MEMORANDUM

Subject: Supplemental Analysis and Findings of Fact for the American Exchange, Block 101 (1 N Pinckney St), Madison, WI

TECHNICAL MEMORANDUM

Subject: American Exchange, Block 101 (1 N Pinckney St), Madison, WI City Plan and Code Compliance Findings of Fact

Modified Proposed American Exchange Development

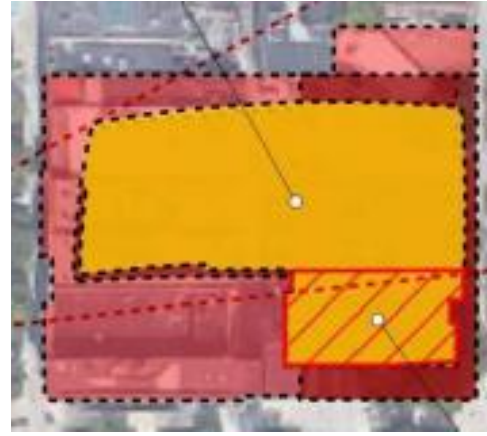
GBA also evaluated the feasibility of incorporating modifications to the ULI proposal based on recommended design improvements from UDC Commissioners during the ULI informational presentation at the May 27, 2020 Urban Design Commission meeting. Specifically, GBA evaluated the feasibility of mirroring the office tower and decreasing the height modestly along the East Washington Ave portion of the office tower as shown on the two figures on the following page. The results of this feasibility analysis determined that the ULI design can be modified to: a) preserve approximately the same density (300,000 SF) in the current ULI development proposal, b) accommodate a similar structural grid as the current ULI proposal, c) incorporate ULI's desired first and second floor uses with modest reconfiguration, and d) not significantly modify the ramping or number of parking stalls

incorporated into the subterranean parking. Significantly, as illustrated in the Figure to the right, the feasibility analysis demonstrated and GBA concluded that the ULI proposal can in fact be modified to not

substantially depreciate, adversely impact, diminish or impair the uses, values, and enjoyment of an important public amenity while still accomplishing the desired development density and program.

ULI Proposed American Exchange Development

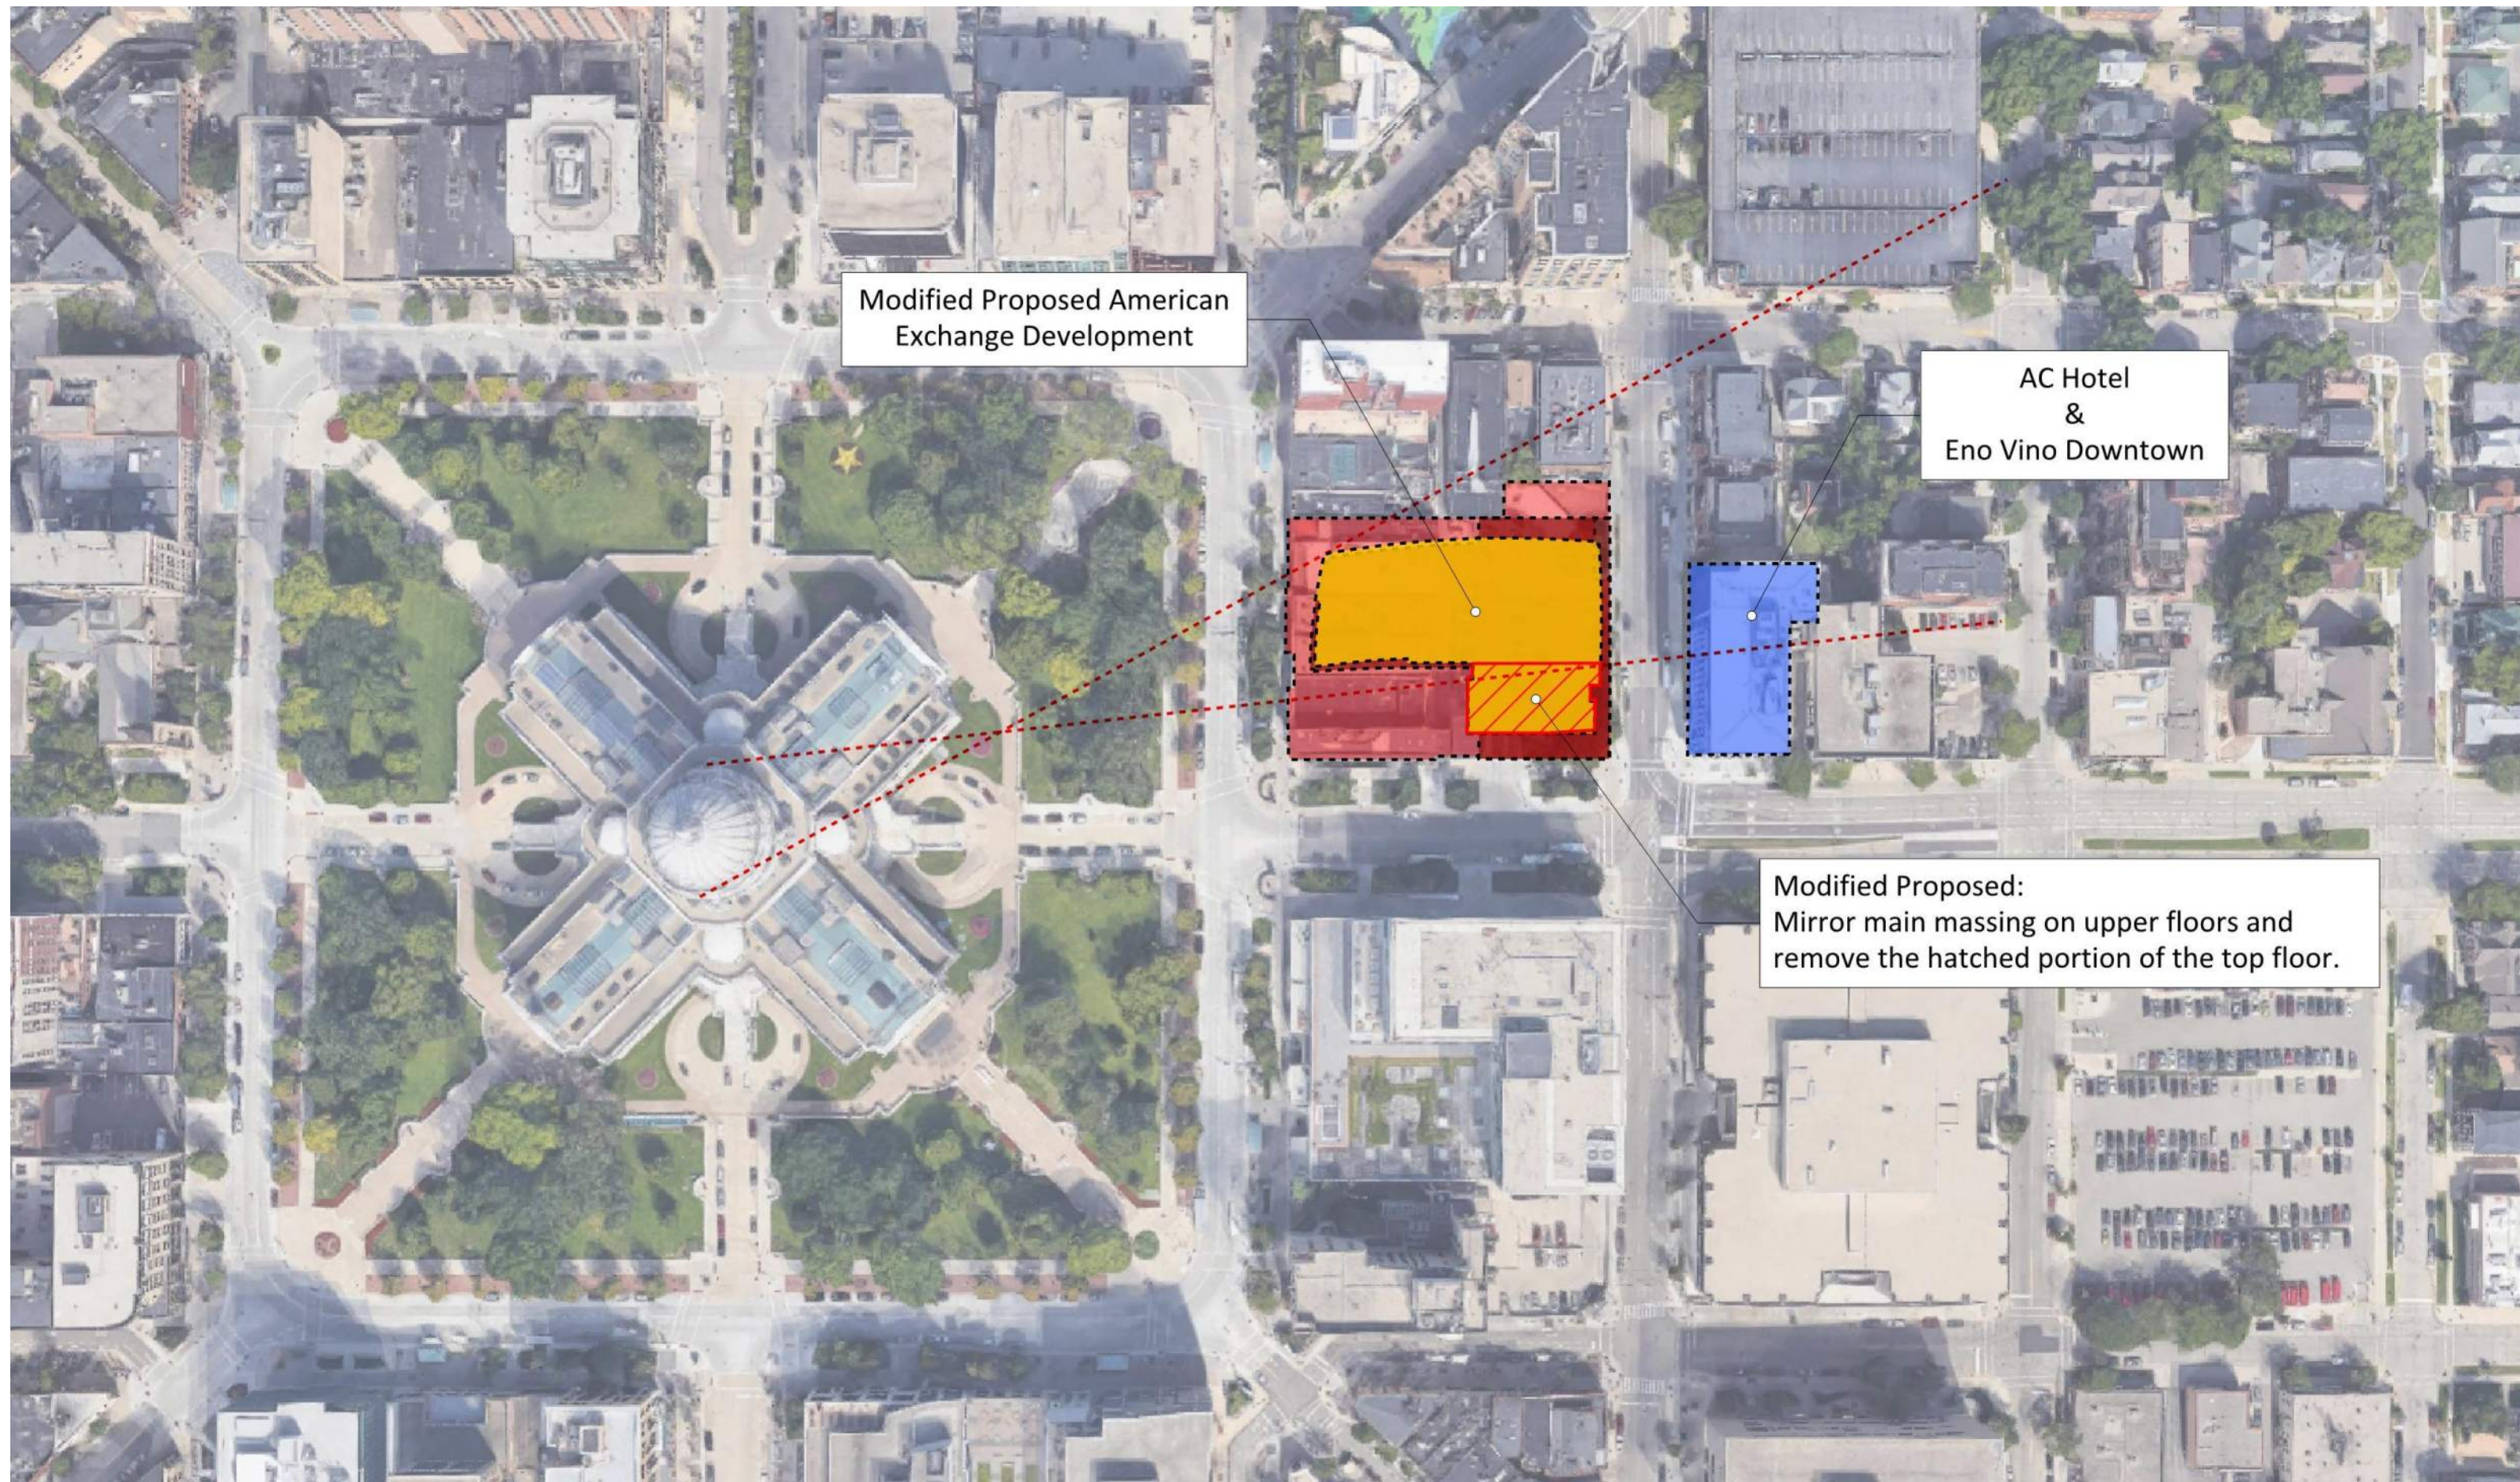
21'-0" Stepback at 8th Floor.

Modified Proposed: Mirror main massing on upper floors and remove the hatched portion of the top floor.

ULI Proposed American Exchange Development

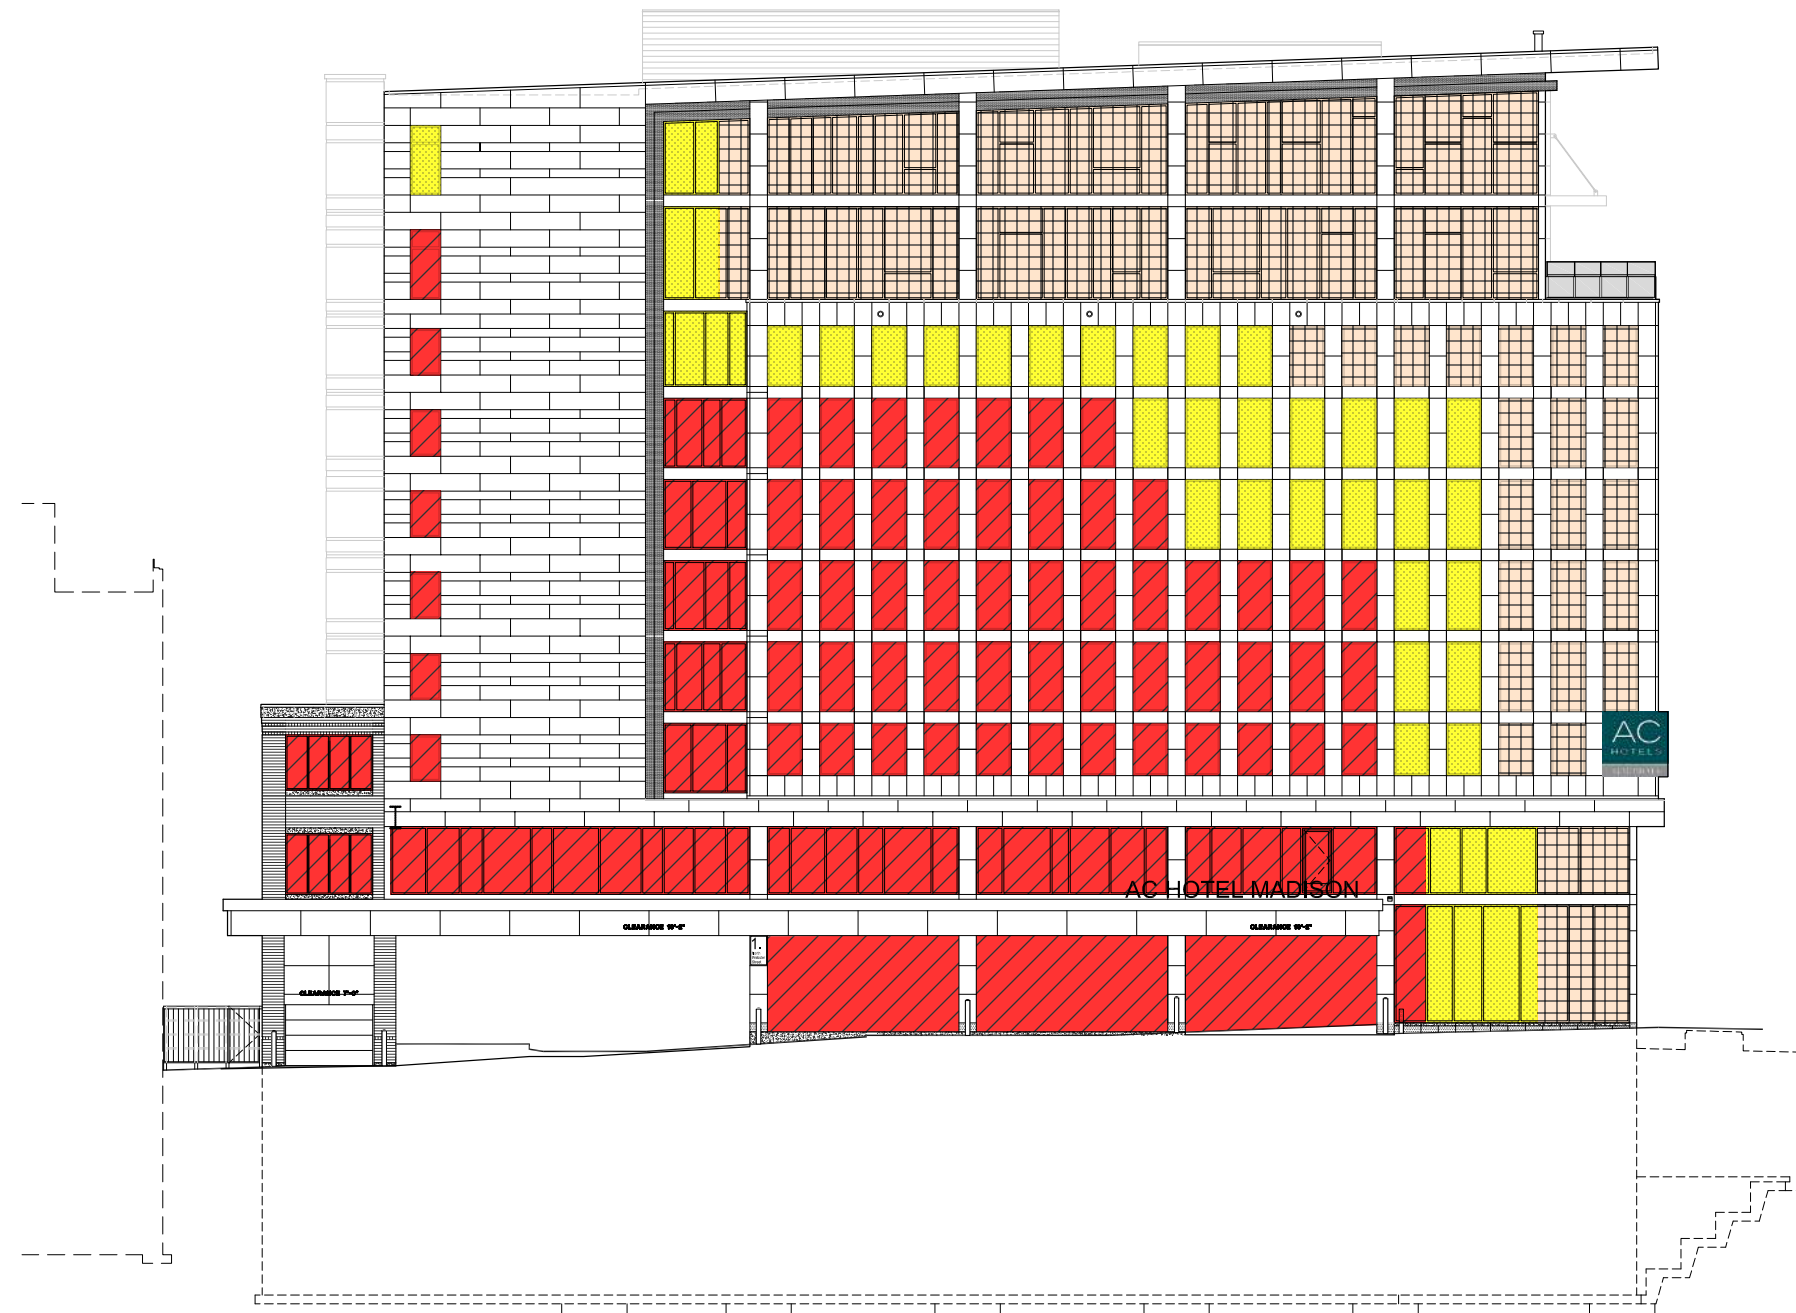
Under the proposed ULI Development, there will be a great impact to the Capitol view from the AC hotel. The ULI Development will block approximately 75% of the building from having any view of the Capitol dome. 15% of the building will suffer a partial blocked view of the dome, and 10% will have a partial blocked view of the Capitol overall.

With the Proposed Modification to the ULI Development, the large impact to the Capitol view from the AC hotel will be reduced. The proposed modification will allow a majority of the 9th and 10th floors of the AC and Eno Vino to have full Capitol Dome views. The full impact to the Capitol Dome is reduced by approximately 24%, with a majority of this percentage shifting to allow for more full Capitol Dome views.
